**INTERIM CHANGE NOTICES (ICN) FOR RESOURCE CONSERVATION AND  
RECOVERY ACT (RCRA) GROUNDWATER (GW) MONITORING PLANS**

Attached please find ICNs for seven GW monitoring plans, for your information. The following table summarizes the attached ICNs:

**INTERIM CHANGE NOTICE  
(ICN)**

Document Title: Combination RCRA Groundwater Monitoring Plan for the  
216-A-10, 216-A-36B, and 216-A-37-1 PUREX Cries

**Figure 3.1. Facility Layout and Locations of Monitoring Wells for the 216-B-3 Pond System.**

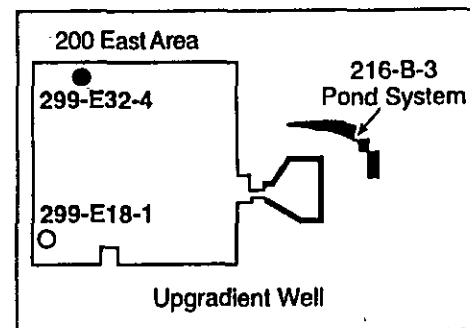
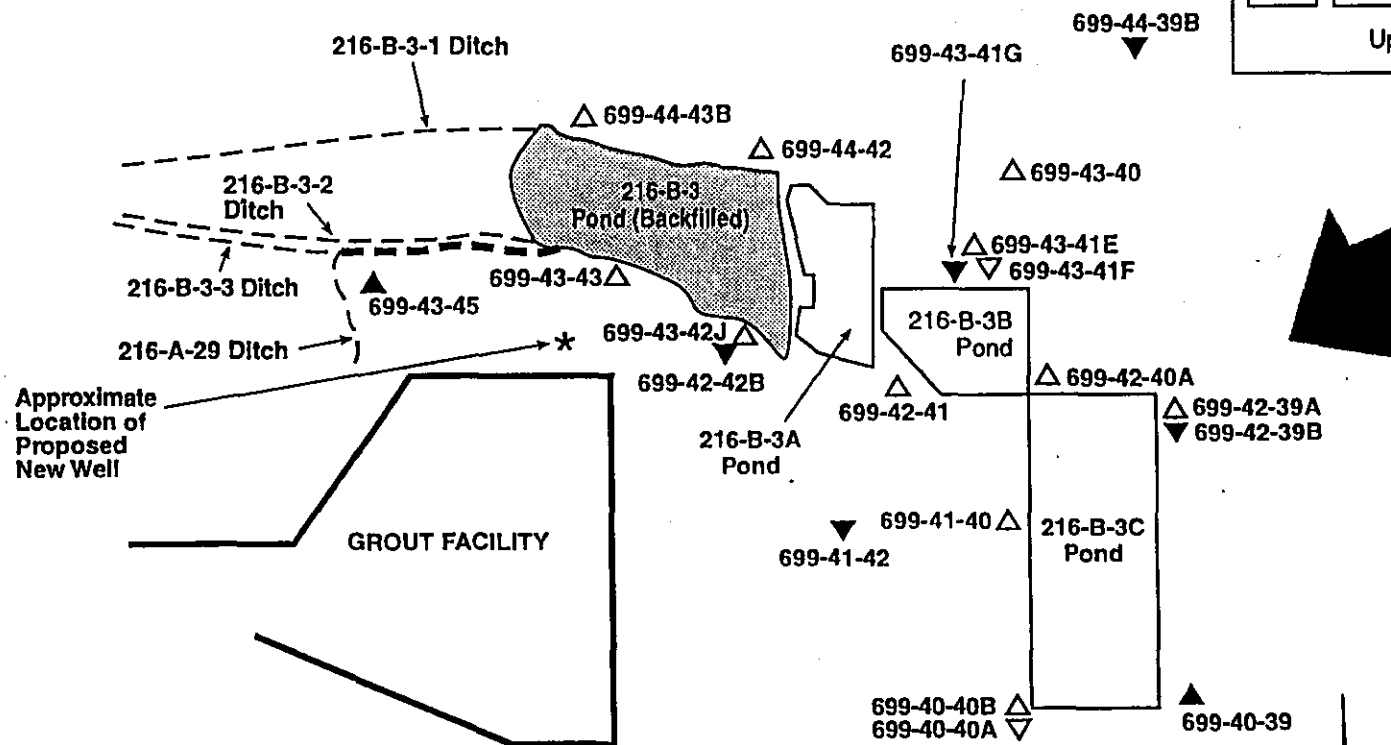
The existing array of wells around the B Pond System provide more than an adequate number of potential monitoring points from which to select. The possible exception is the area immediately southwest of the B Pond, for which a new well is proposed. The revised well network is shown in Figure 3.1. In all, 9 wells (8 downgradient) are proposed for the revised network.

The potential sources of groundwater contamination from the facility and groundwater flow directions (see discussion in Section 3.4.2), indicate that additional monitoring coverage is needed immediately southwest of the main pond. Hence, a RCRA-compliant, downgradient well is proposed for the location shown in Figure 3.1. The well will be screened over an extended interval to accommodate rapidly falling water levels and lengthen the service life of the well, and to intercept contamination at different levels in the aquifer. The well will be drilled to basalt (base of the uppermost aquifer) and screened below the water table. Upon completion, the well will be sampled for the Appendix IX list of constituents, and thereafter for the list of parameters shown in Table 11.

Figure 3.2. Water Table Map for the B Pond Area, June 1998.

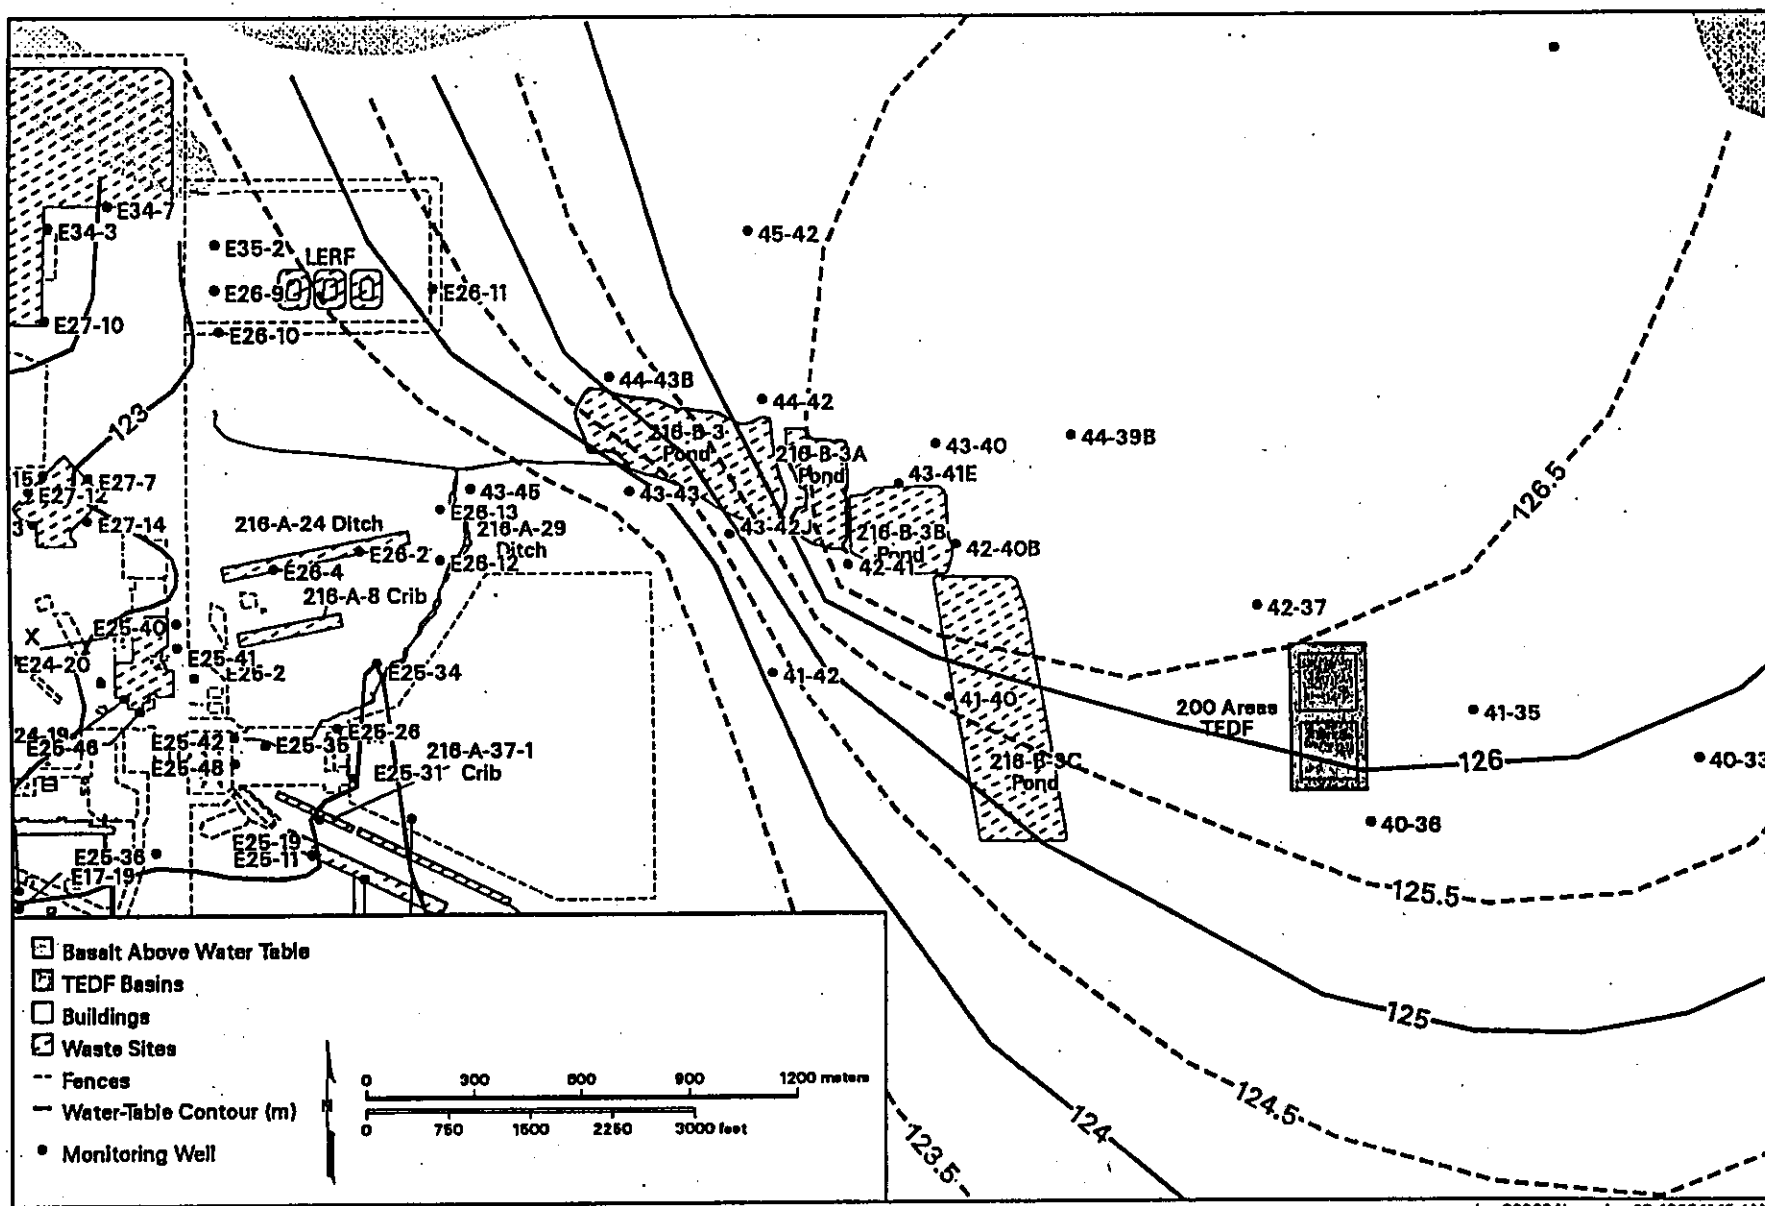
A comparison of these well locations with the June 1998 potentiometric surface is shown in Figure 3.2. Well 299-E32-4, in the northwest portion of the 200 East Area, will remain as the upgradient monitoring location.
